VALLEY VIEW LOCAL SCHOOLS
Germantown, Ohio

Addendum No. 1

BOARD OFFICE RENOVATION PROJECT

Prepared by:
The Oregon Group Architects
300 S. Patterson Blvd.
Dayton, Ohio 45402
937-228-1511
Kyle Zepernick
kzepernick@oregongroup.com

DEMOLITION FLOOR PLAN
SCALE: 1/4"=1'-0"

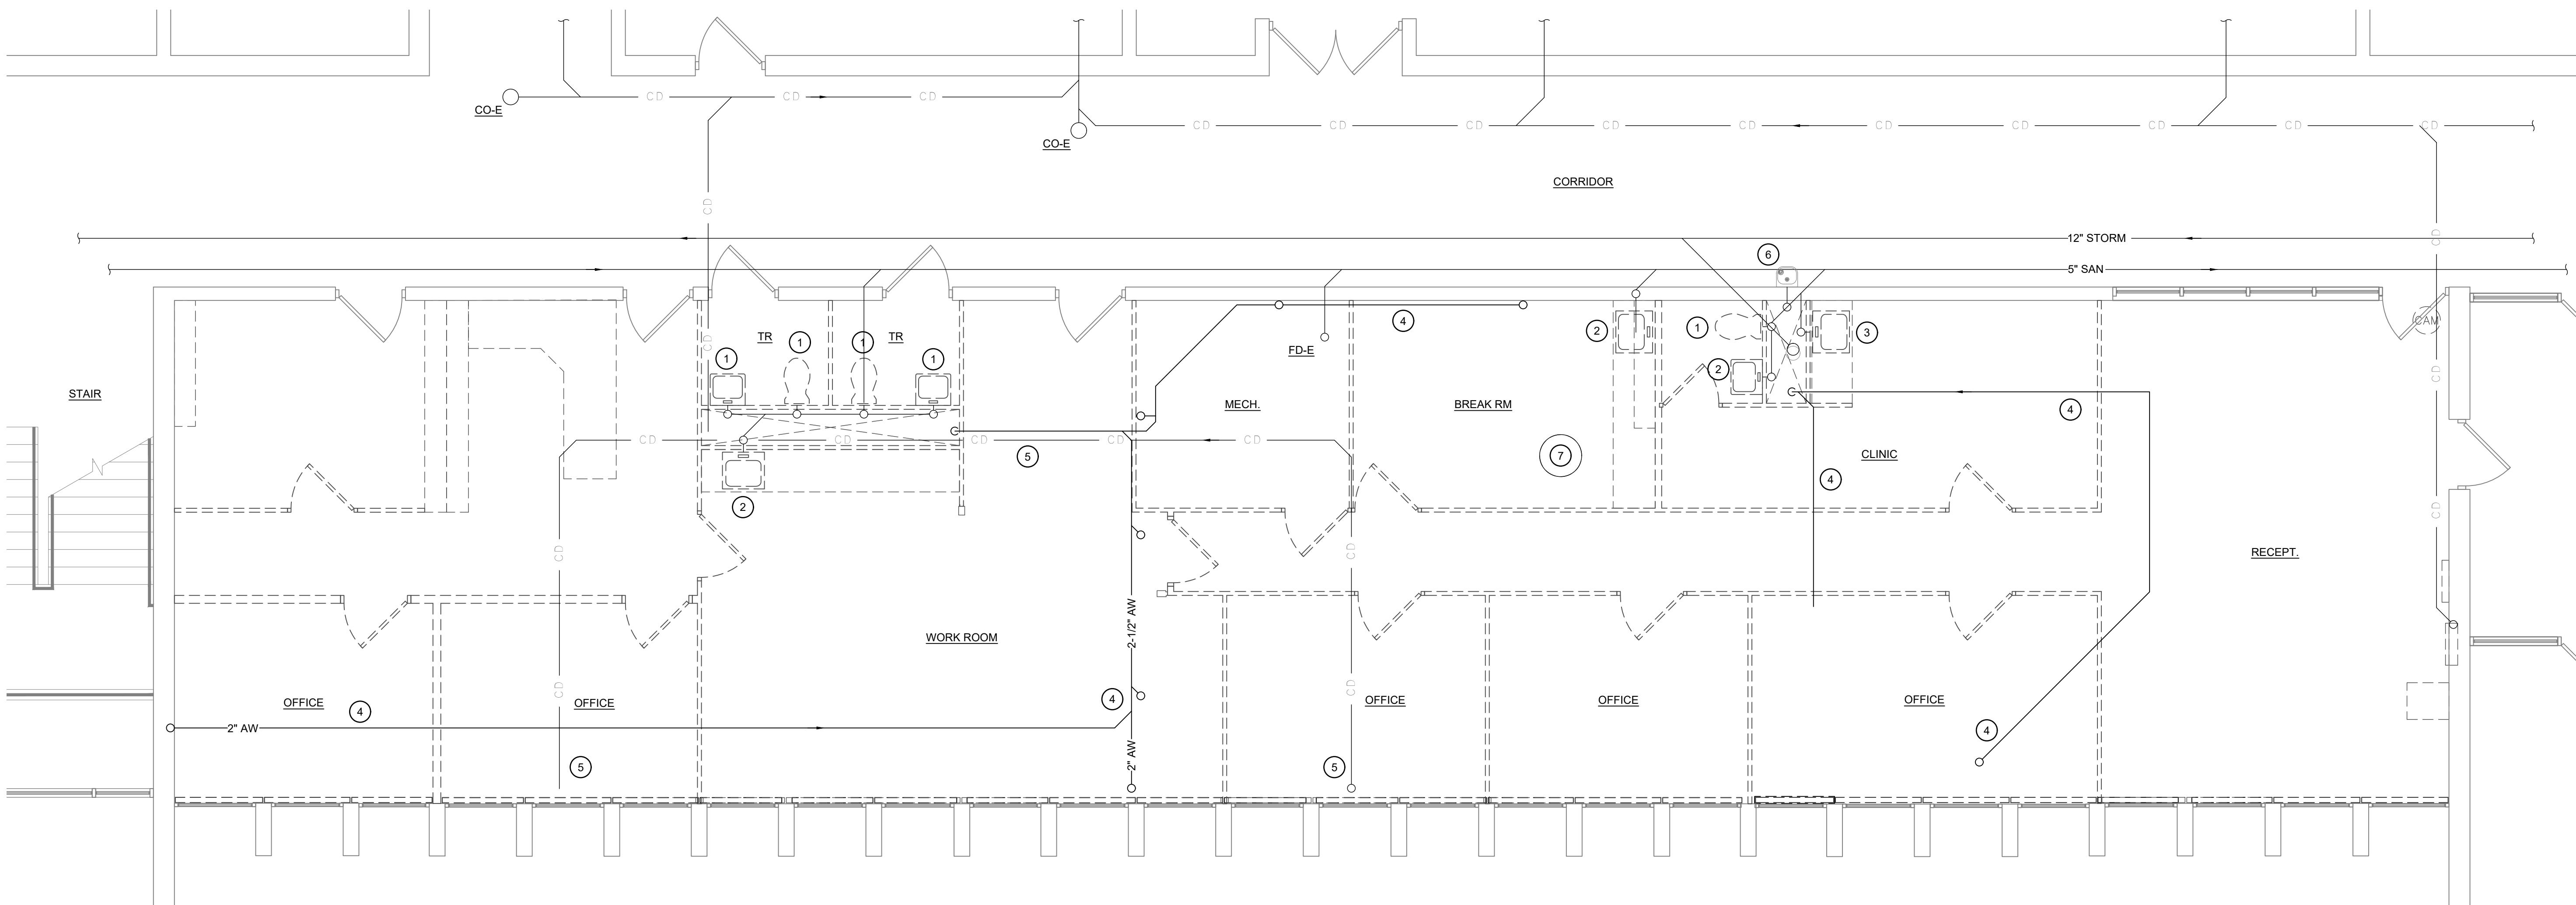
Item No. 12: Sheet P1.1, Demolition Notes #1 and #2 revised to refer to the floor patching detail in the Architectural drawings.

1. DEMO EXISTING PLUMBING FIXTURE. NEW FIXTURE GOING BACK IN APPROXIMATELY THE SAME LOCATION. VERIFY DIMENSIONS WITH ARCHITECTURAL SET. REMOVE PIPE WITHIN WALL TO ACCOMMODATE THE NEW WALL CONSTRUCTION AND LOCATION. CUT AND PATCH FLOOR AS NECESSARY TO MODIFY DRAIN CONNECTION AND FIXTURE CARRIER LOCATION. REFER TO FLOOR PATCHING DETAIL IN ARCHITECTURAL SET.

2. DEMO EXISTING PLUMBING FIXTURE. NEW FIXTURE WILL BE IN A NEW LOCATION. VERIFY DIMENSIONS WITH ARCHITECTURAL SET. REMOVE PIPE WITHIN WALL. SHAVE OUT FLOOR AND REVERSE EXISTING ROUTING AS NECESSARY TO ACCOMMODATE NEW FIXTURE LOCATION. REFER TO FLOOR PATCHING DETAIL IN ARCHITECTURAL SET. COORDINATE WITH OTHERS IF MODIFICATIONS CAN BE MADE ABOVE FLOOR WITHIN WALLS AND CABINETS.

office renovation for:
valley view board of education
6027 farmersville pike
germantown, ohio 45327
plumbing new work plan

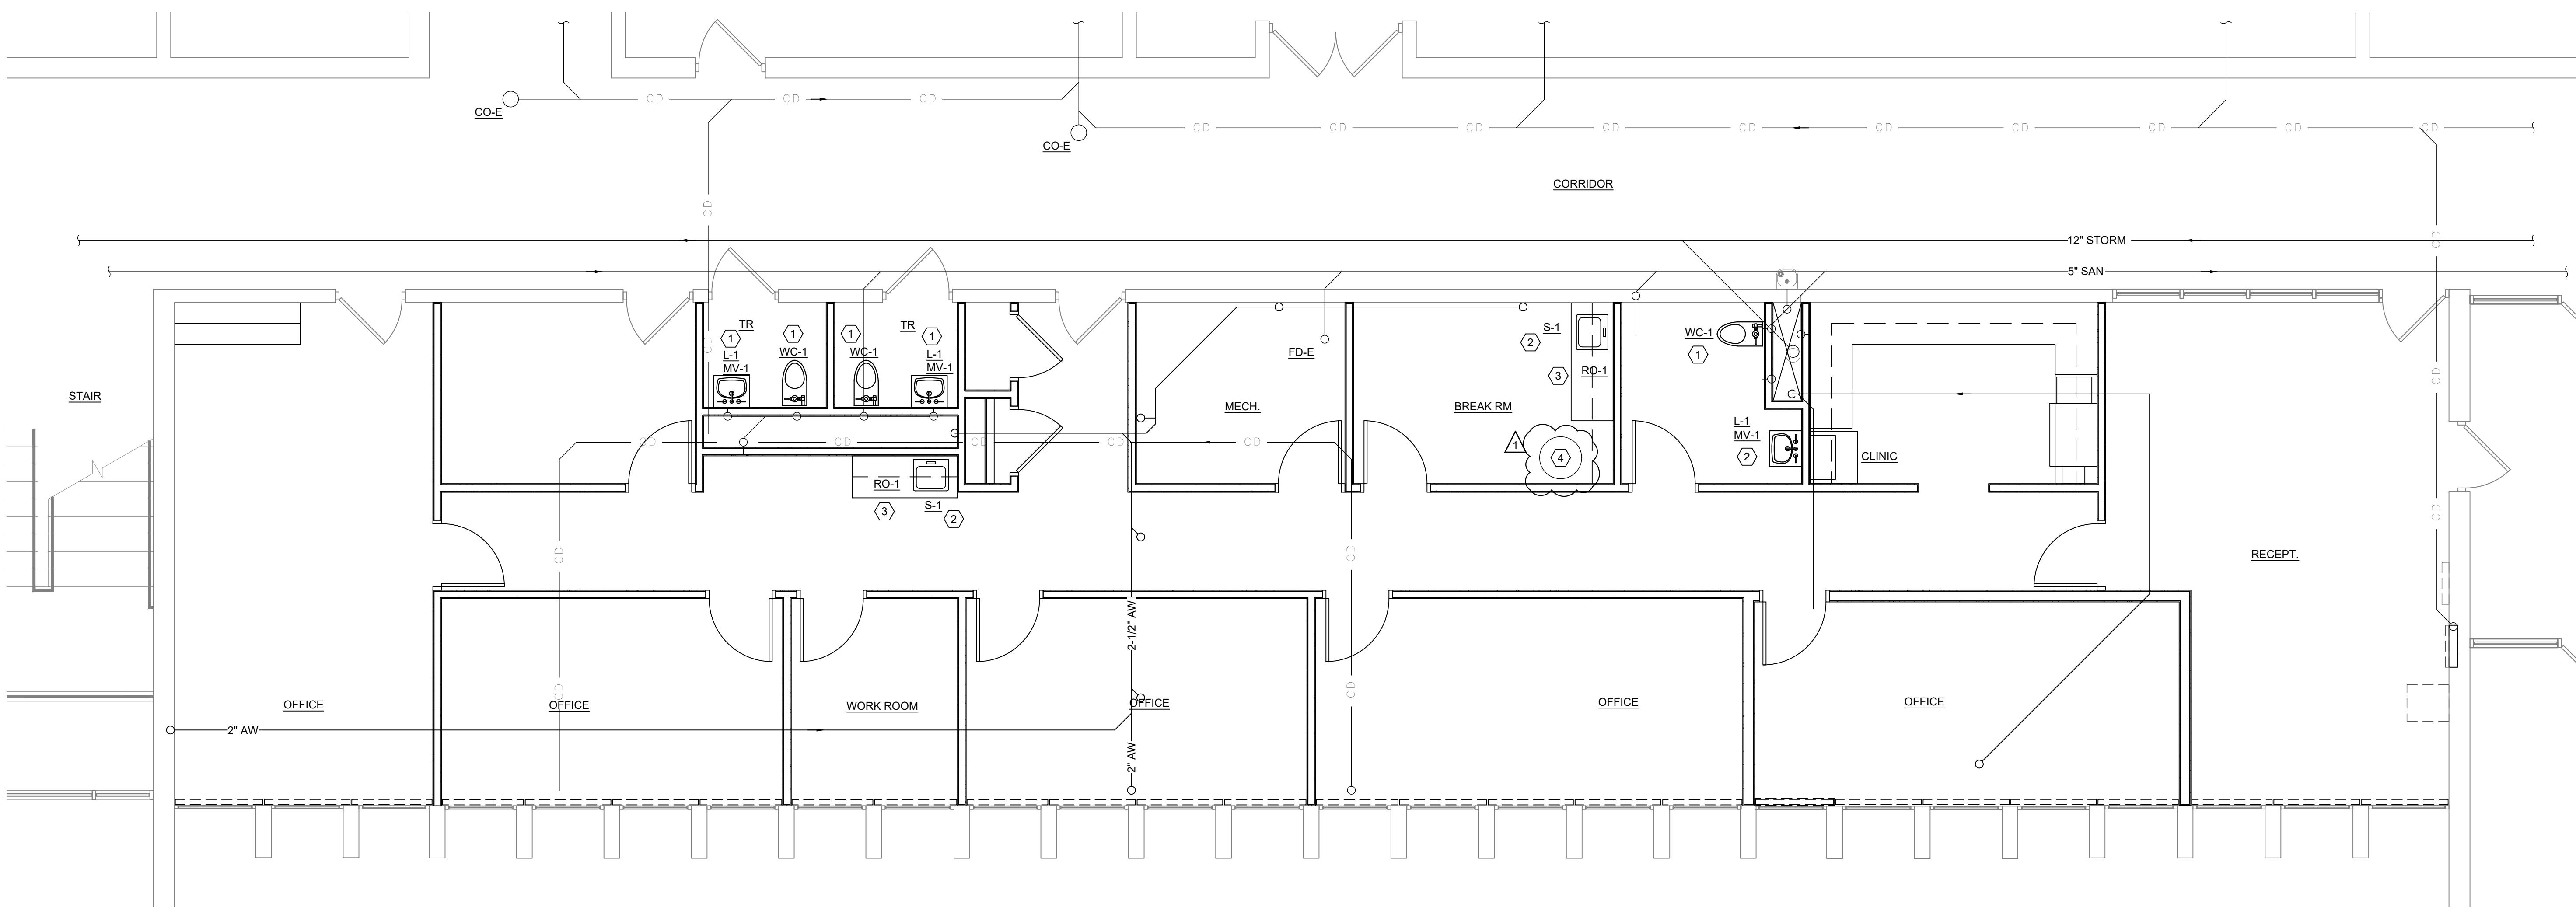
Item No. 13: Sheet P2.1, Installation Notes #1 and #2 revised to refer to the floor patching detail in the Architectural drawings.

Item No. 14: Sheet P2.1, Installation Note 4 added and applied to the plan view. Reads, “EXISTING MANHOLE COVER AND BASIN TO REMAIN. GENERAL CONTRACTOR TO COVER WITH FLOORING. DRAIN SYSTEM NO LONGER BEING USED FOR CHEMISTRY LABORATORIES AND WILL NOT REQUIRE REGULAR MAINTENANCE AS IT IS NO LONGER PROVIDING NEUTRALIZATION.”

1. PROVIDE NEW PLUMBING FIXTURE IN APPROXIMATELY THE SAME LOCATION AS THE EXISTING FIXTURE. REPLACE PIPE WITHIN WALL, PATCH FLOOR AS NECESSARY. REFER TO FLOOR PATCHING DETAIL IN ARCHITECTURAL SET. PROVIDE NEW FIXTURE CARRIER (WHERE APPLICABLE).

2. PROVIDE NEW PLUMBING FIXTURE IN NEW LOCATION. EXTEND PIPE IN WALL AND FLOOR BACK TO NEAREST TIE-IN POINT. PATCH FLOOR AS NECESSARY. REFER TO FLOOR PATCHING DETAIL IN ARCHITECTURAL SET. PROVIDE NEW FIXTURE CARRIER (WHERE APPLICABLE).

NEW WORK FLOOR PLAN

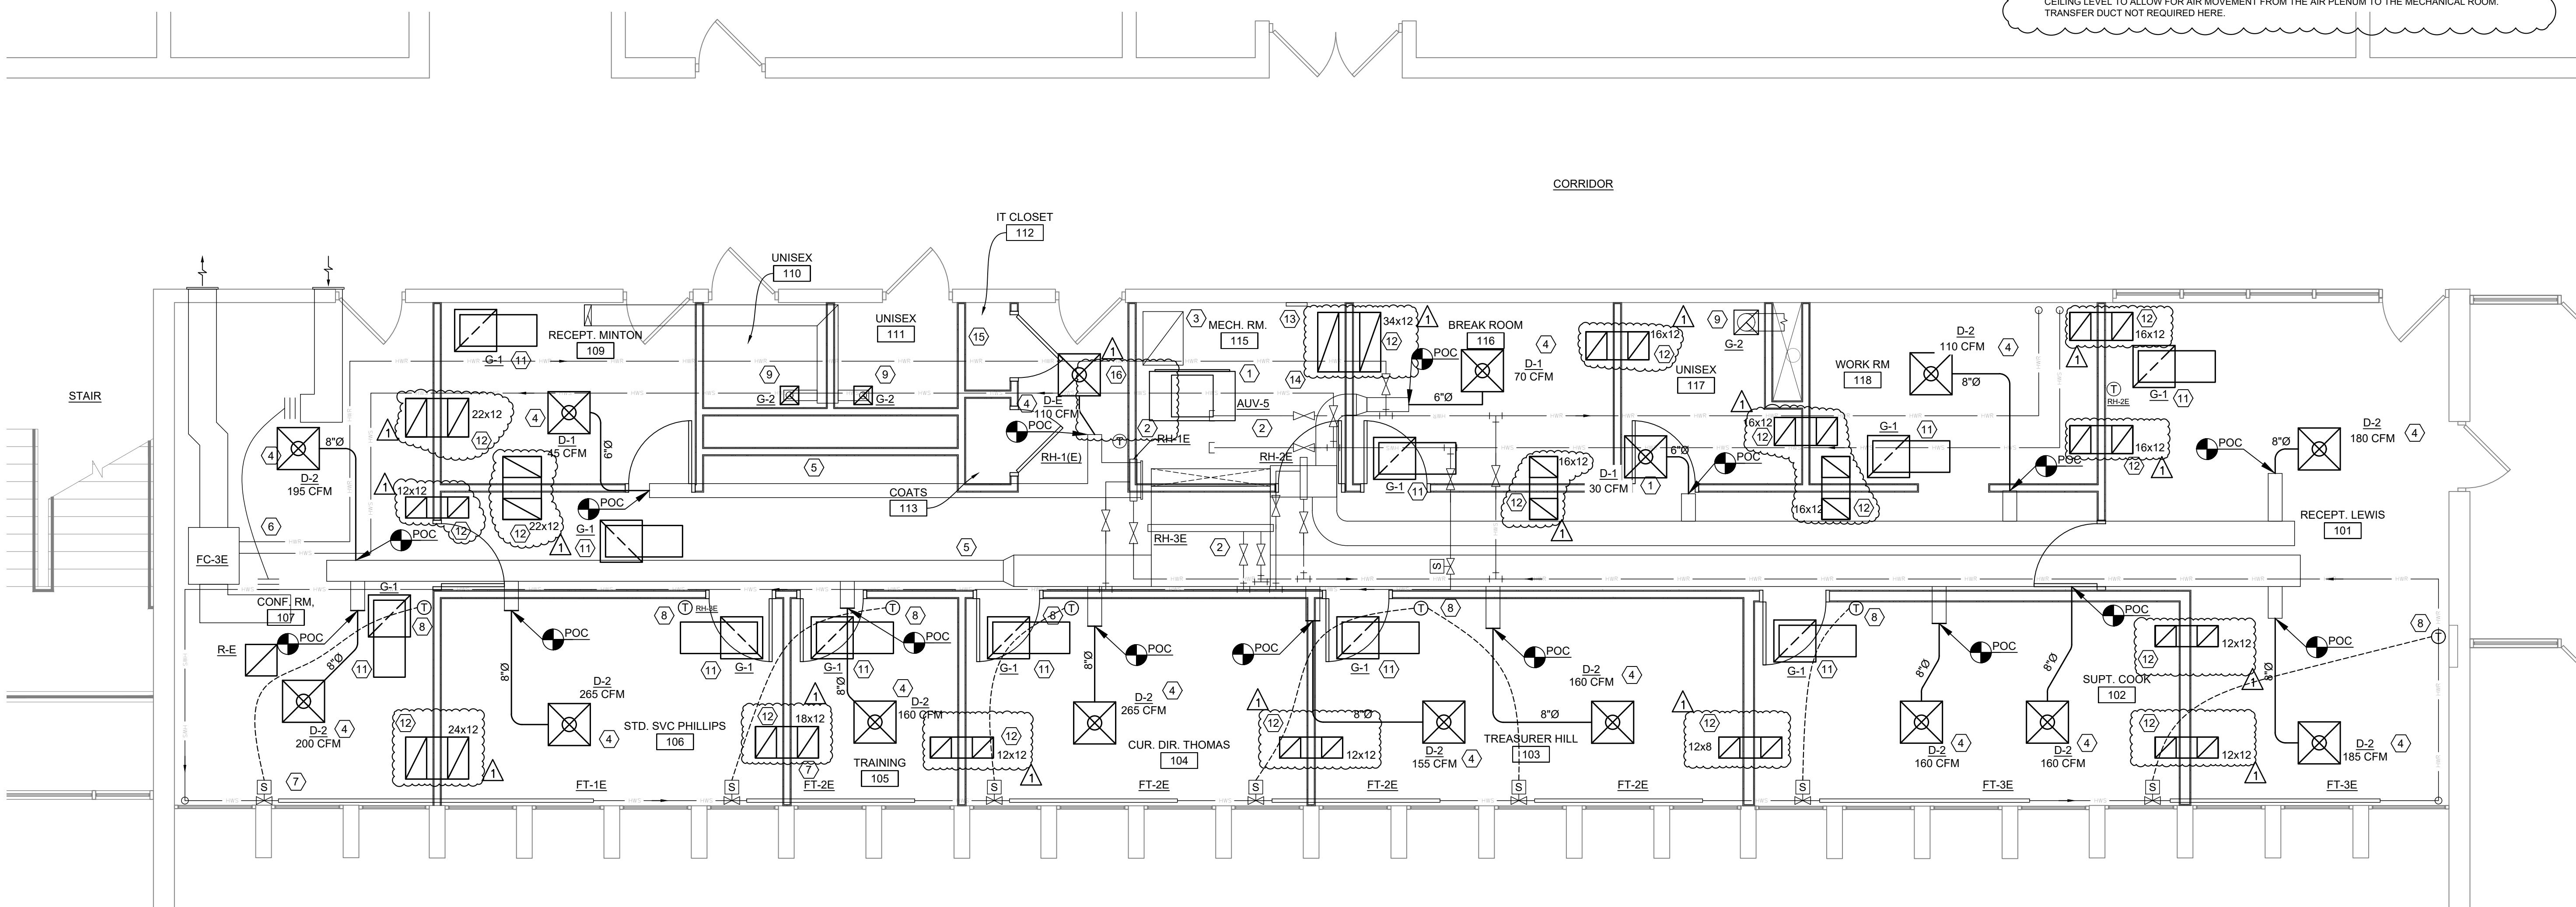
Item No. 15: Sheet M2.1, The return air sound traps have been sized and quantities updated. These were previously shown, but not sized.

Item No. 16: Sheet M2.1, Installation Note 16 added and applied to the plan view. Read “THE SOUTH AND EAST WALL OF THE MECHANICAL ROOM WILL HAVE OPEN STUD BAYS ABOVE THE CEILING LEVEL TO ALLOW FOR AIR MOVEMENT FROM THE AIR PLENUM TO THE MECHANICAL ROOM. TRANSFER DUCT NOT REQUIRED HERE.”

16. THE SOUTH AND EAST WALL OF THE MECHANICAL ROOM WILL HAVE OPEN STUD BAYS ABOVE THE CEILING LEVEL TO ALLOW FOR AIR MOVEMENT FROM THE AIR PLenum TO THE MECHANICAL ROOM. TRANSFER DUCT NOT REQUIRED HERE.

RETURN AIR SOUND TRAP DETAIL

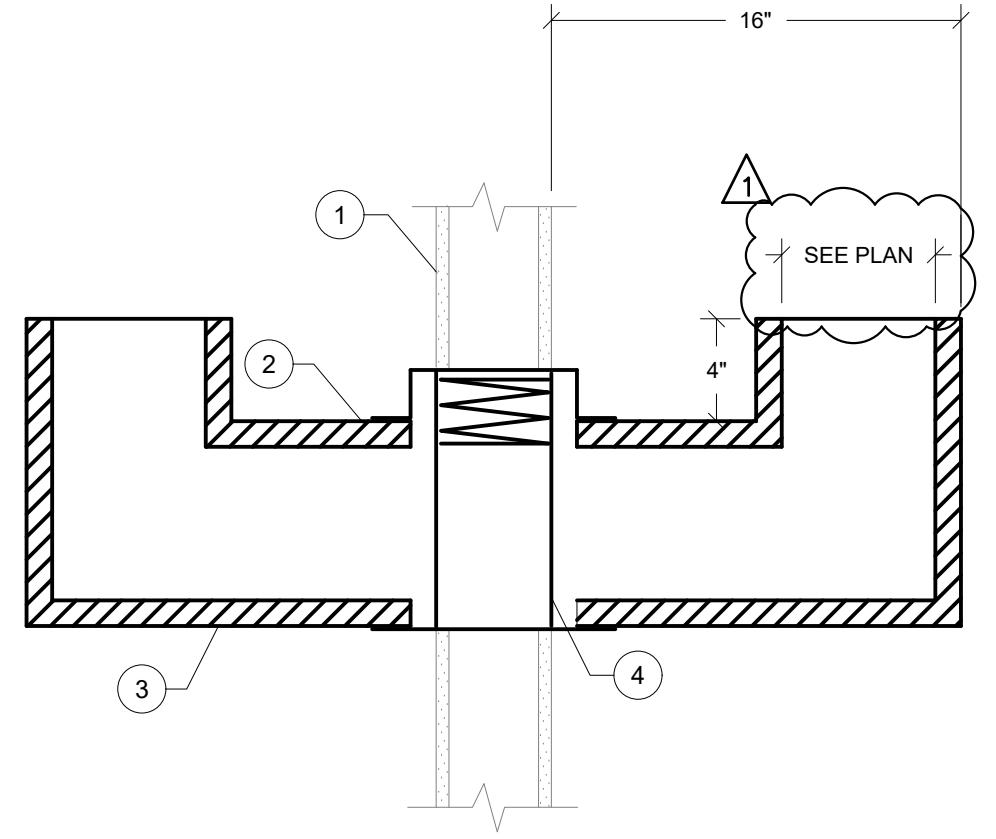
Item No. 21: Sheet M5.2, On the Return Air Sound Trap Detail, the duct dimension has been revised to read “SEE PLAN.”

# DETAIL NOTES	
1. FIRE RATED PARTITION	
2. SEE PLANS FOR DUCT SIZE AND ELEVATION	
3. ACOUSTICALLY LINED DUCTWORK FOR SOUND ABSORPTION	
4. FIRE DAMPER WHERE REQUIRED, SEE PLANS. CARRY DUCT THROUGH NON-RATED WALL AND SEAL OPENING

SOUND BOOT DETAIL

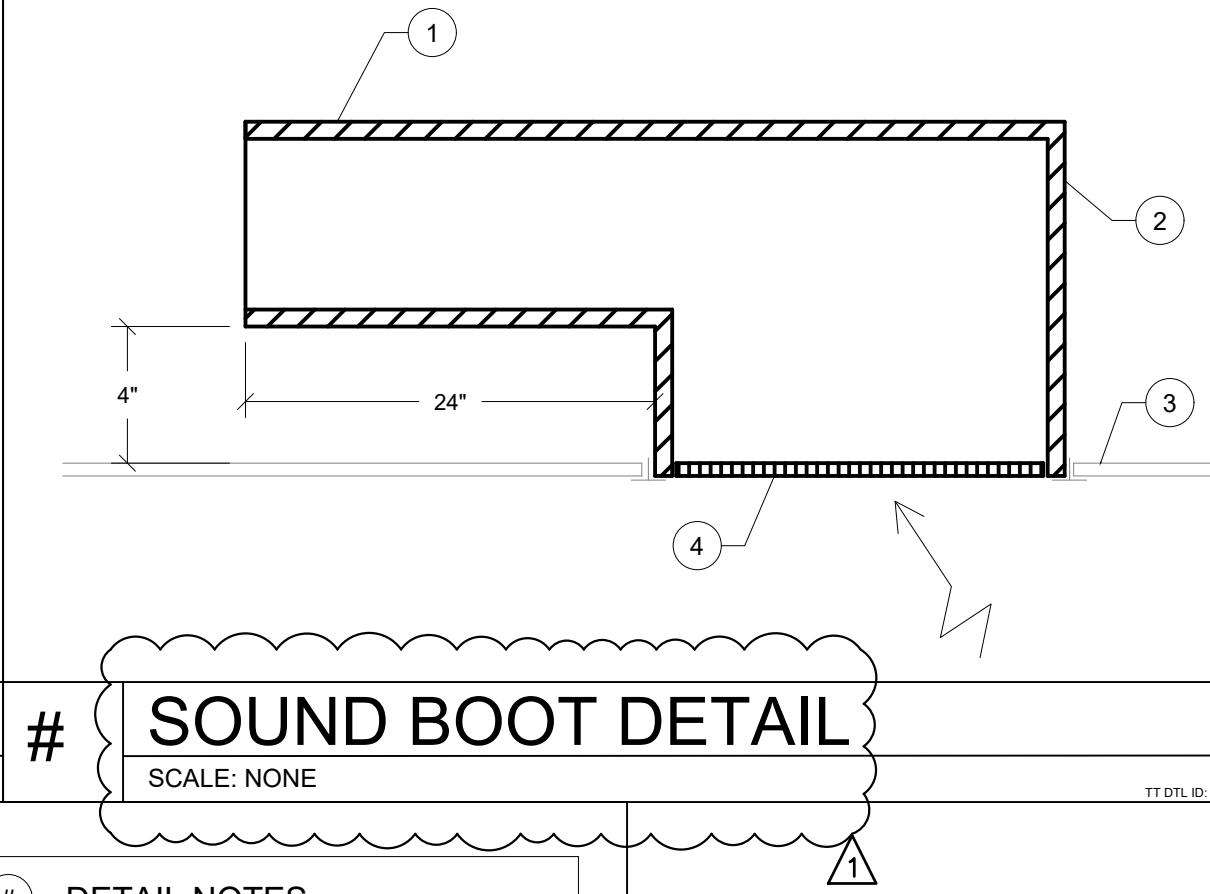
Item No. 20: Sheet M5.2, “Air Transfer Detail” renamed to “Sound Boot Detail” as it is referred to a sound boot on other sheets.
